Project	PCIe Timing Interface		LIGO Laboratory California Institute of Technology Massachusetts Institute of Technology National Science Foundation
Sheet Title	Timing Interface		
Size:	B-C-D	DCC D2000329	Rev: 1
Date:	3/7/2023	Time: 2:13:16 PM	Sheet: 1 of 12
File:	ChassisTimingInterface1.SchDoc		DrawnBy: M. Pirello

Project <b>PCIe Timing Interface</b>		LIGO Laboratory California Institute of Technology Massachusetts Institute of Technology National Science Foundation	
Sheet Title <b>VCO &amp; Phase Detector</b>		LIGO	
Size: B-C-D	DCC D2000329	Rev: 1	
Date: 3/7/2023	Time: 2:13:18 PM	Sheet: 2 of 12	DrawnBy: M. Pirello
File: ChassisTimingInterface2.SchDoc

# Switched FPGA Power

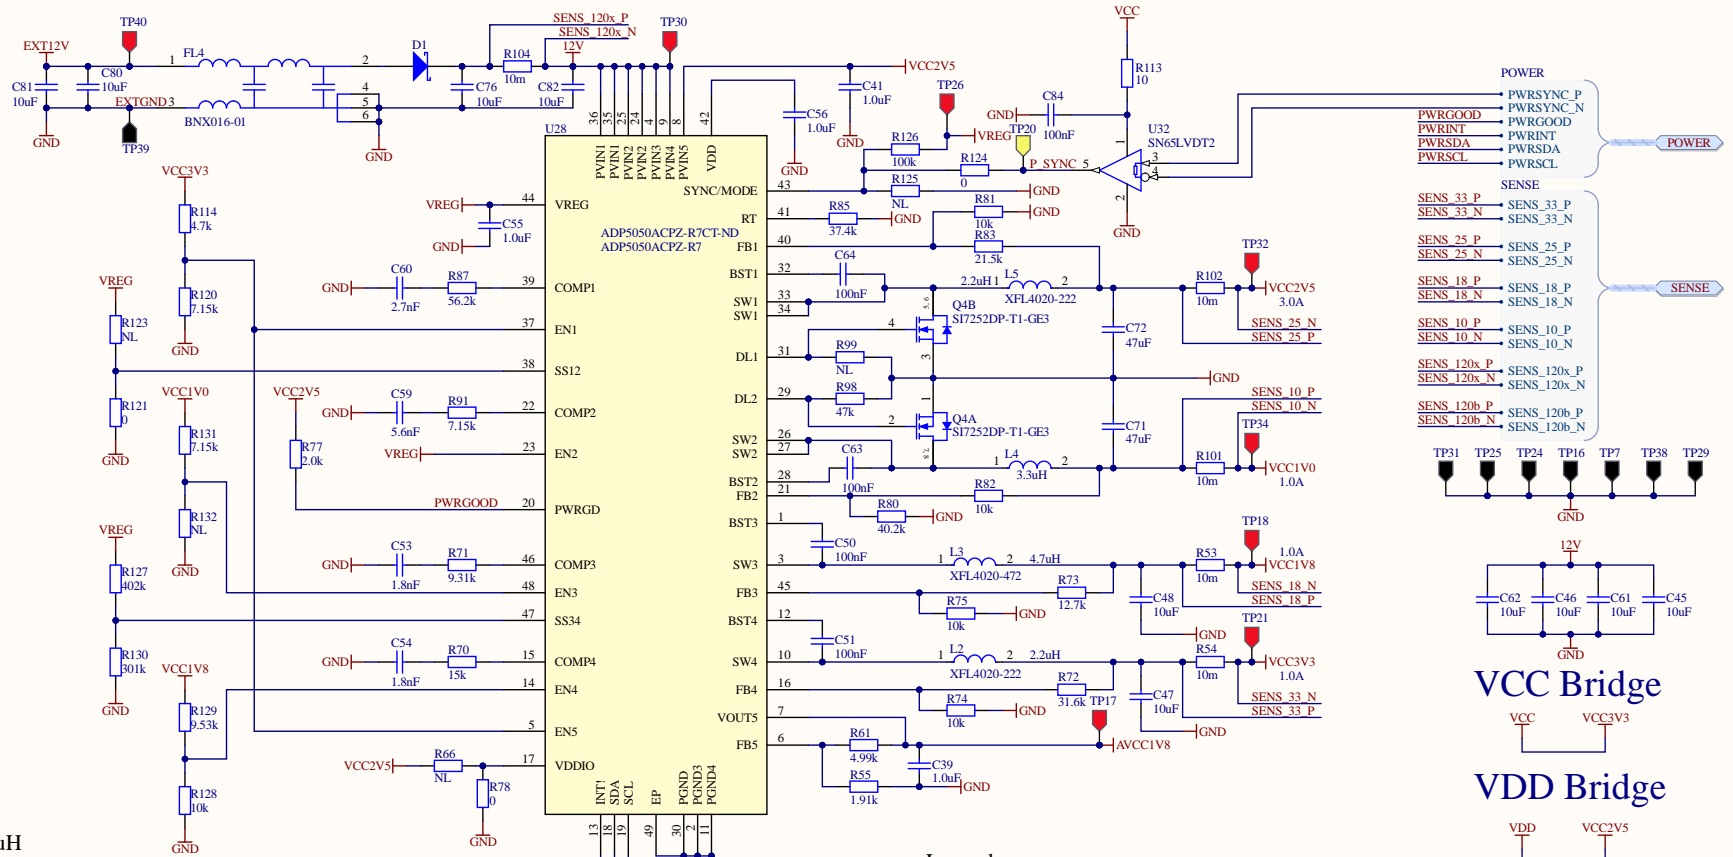
600kHz fsw?  
 RT Sync Calculation (R80)  
 FB1 - 2.5V 21.5k, 10.2k, 2.2uH  
 FB2 - 1.0V 10k, 40k, 3.3uH  
 FB3 - 1.8V 12.7k, 10.2k, 4.7uH (6.8uH)?  
 FB4 - 3.3V 31.6k, 10.2k, 2.2uH (10uH)?  
 FB5 - 1.8V 5k, 1.91k

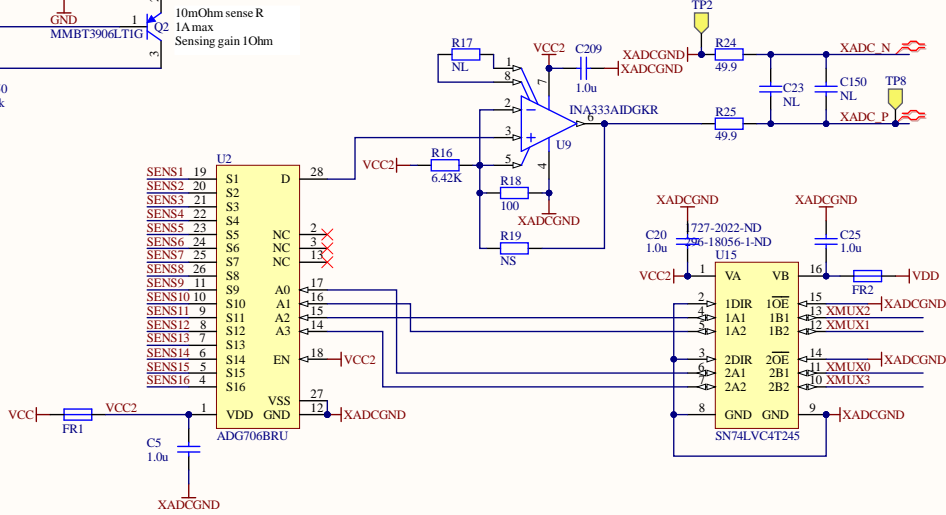
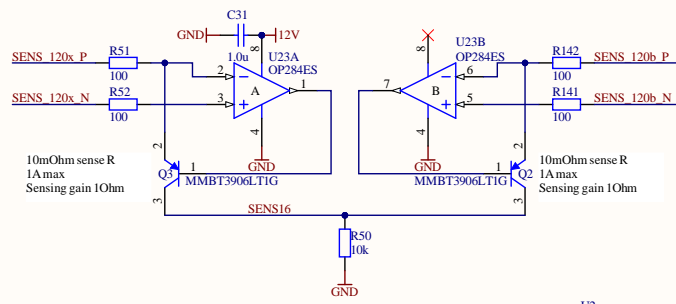
Fix C150 - it is wrong in descriptoin so it fails in BOM manager. Reduce to 100pF 0201. Remove C23 entirely.

Replace Flipflops and Inverters with TSSOP versions. Replace U47 with the 5V version, description is wrong.
